STAFF RECOMMENDATION

402 South 11th Street

January, 21, 2015

Application: New construction - outbuilding

SITE PLAN
 402 S 11th STREET
 1/8" = 1'-0"

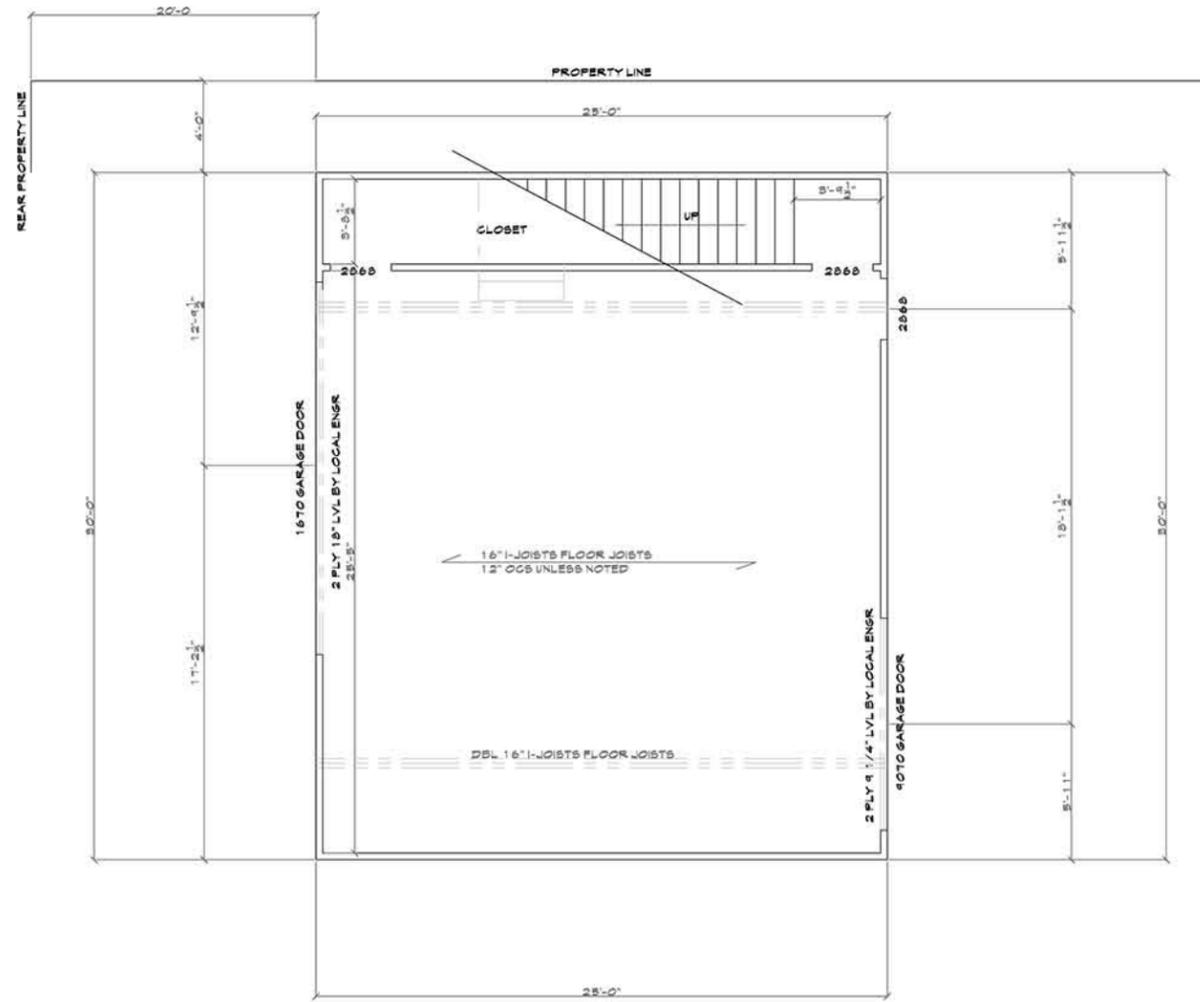
MINIMUM	PROPOSED
Space between principle building and DADU/Garage	20'	70'
Rear setback	3'	16'
L side setback**	3'	13'
R side setback**	3'	6'
How is the building accessed?	From the alley or existing curb cut	Rear/Alley

D: Elevations

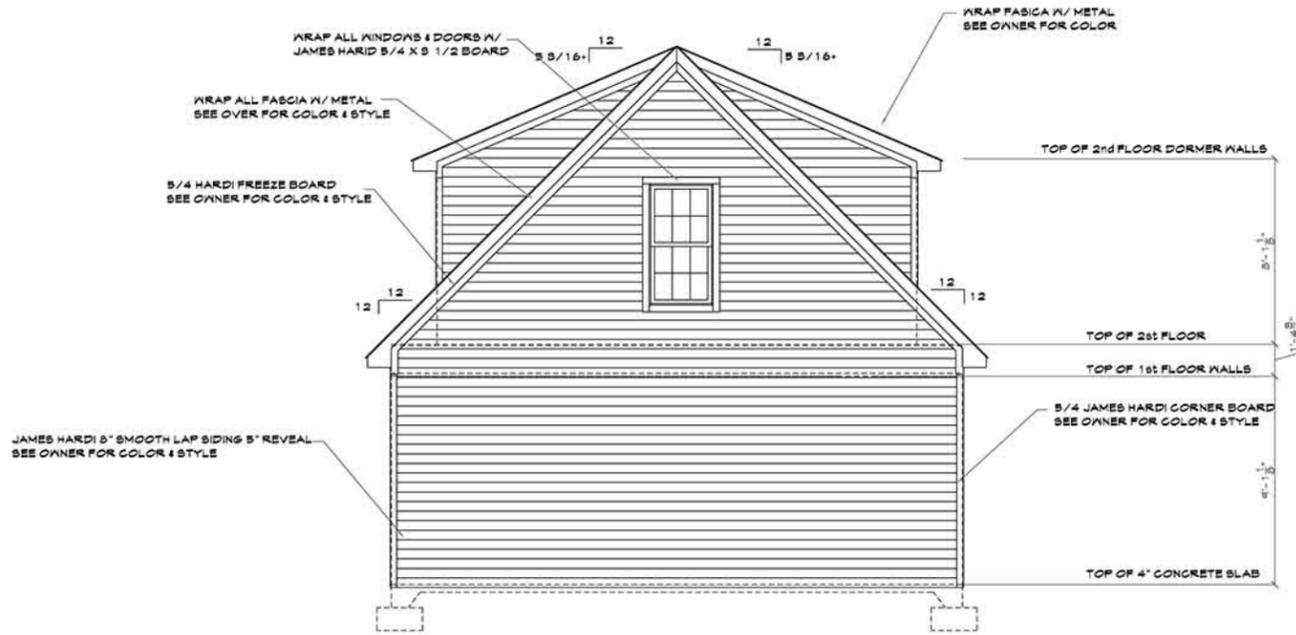
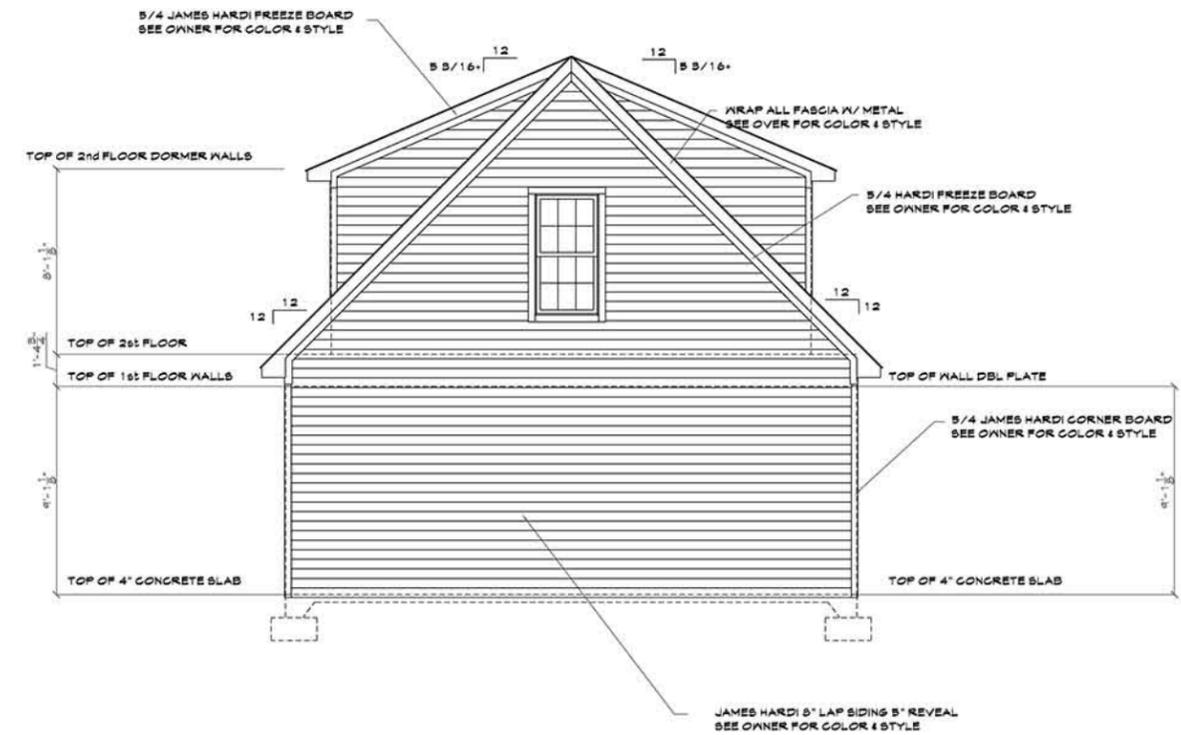
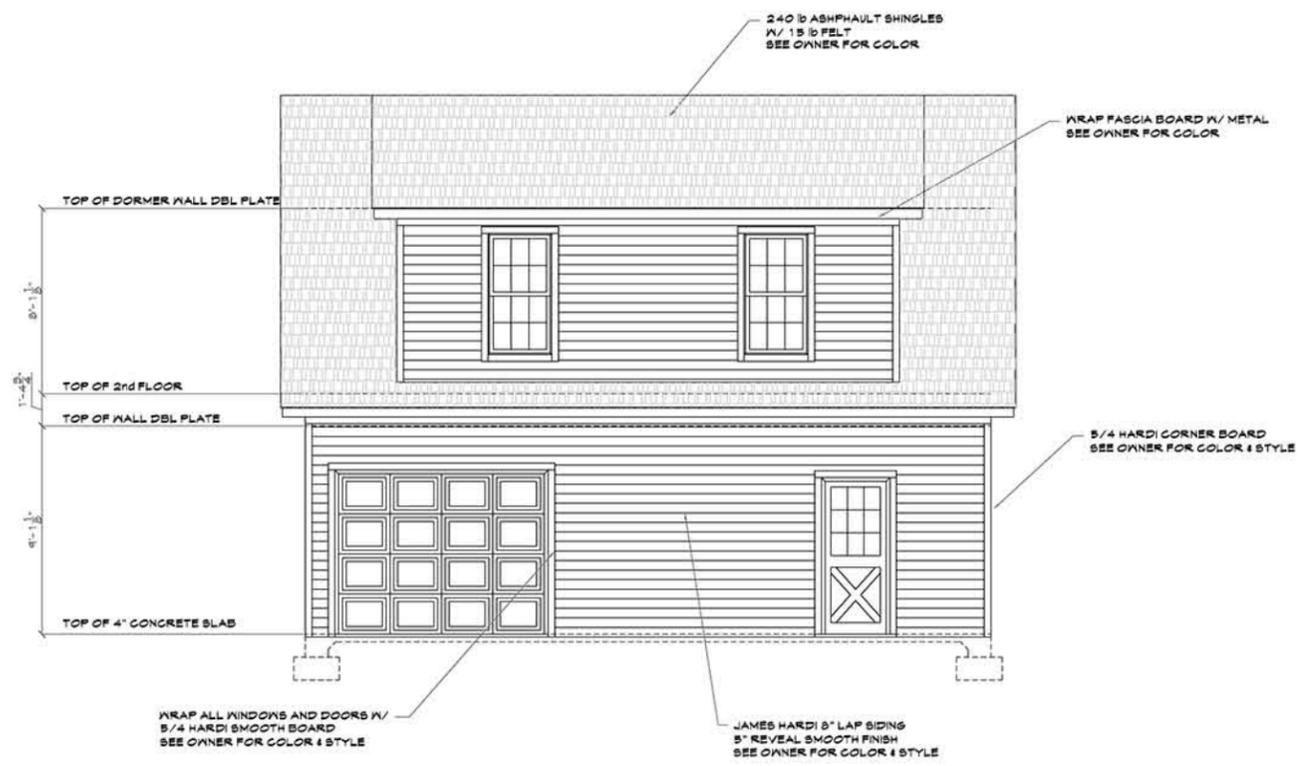
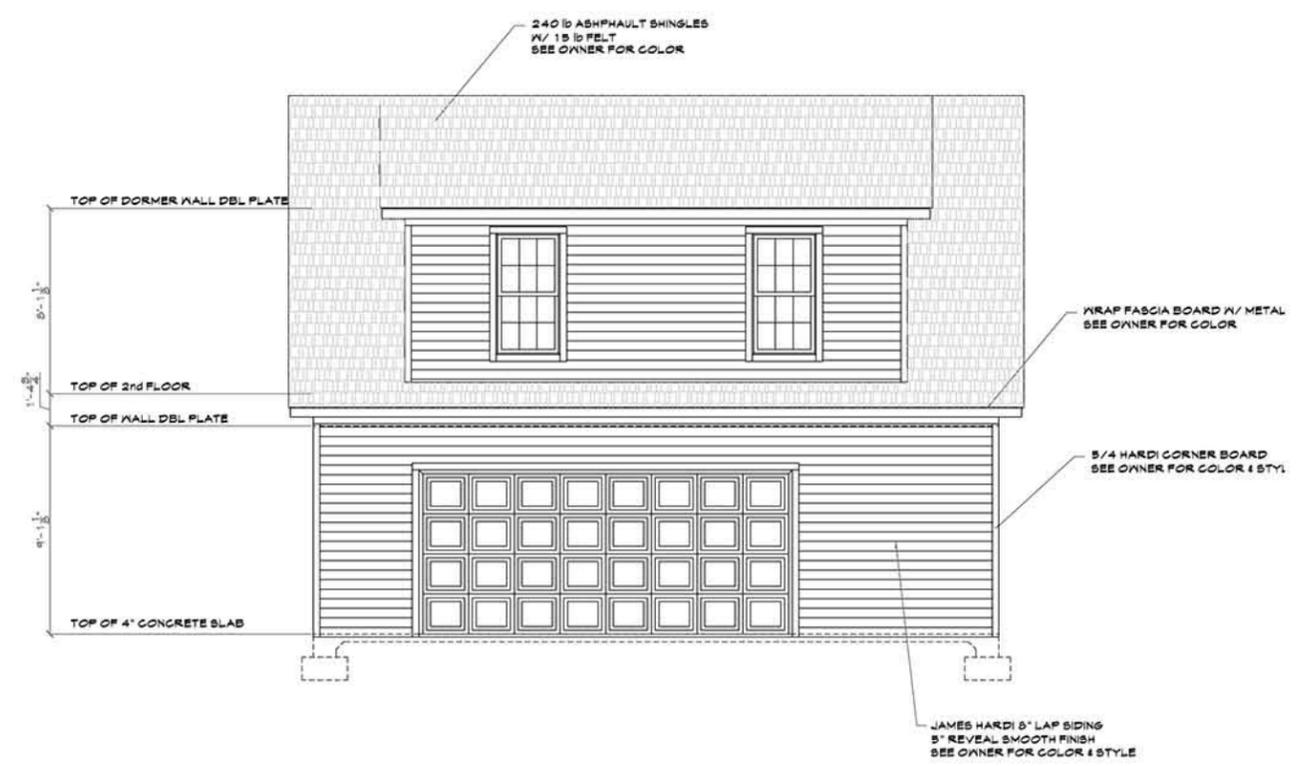
Materials: The outbuilding will be clad with smooth-faced cement-fiber siding with a five inch (5”) reveal, and an asphalt shingle roof matching the color of the roof on the principal building. The material of the windows and doors is not known at this time, and would need to be reviewed by Staff.

Dormers: The dormers on the proposed outbuilding would be seventy-percent (70%) of the width of the roof, which is greater than the fifty-percent (50%) allowed by the design guidelines. However, because the lot is unusually deep and there will be so much space between the proposed outbuilding and the principal building, Staff finds that the visibility of the dormers will be minimal.

Staff recommends approval of the proposed outbuilding with a condition that the windows and doors are approved by Staff prior to purchase and installation. With this condition, Staff finds that the outbuilding meets the design guidelines for outbuildings in the Lockeland Springs-East End Neighborhood Conservation Zoning Overlay.
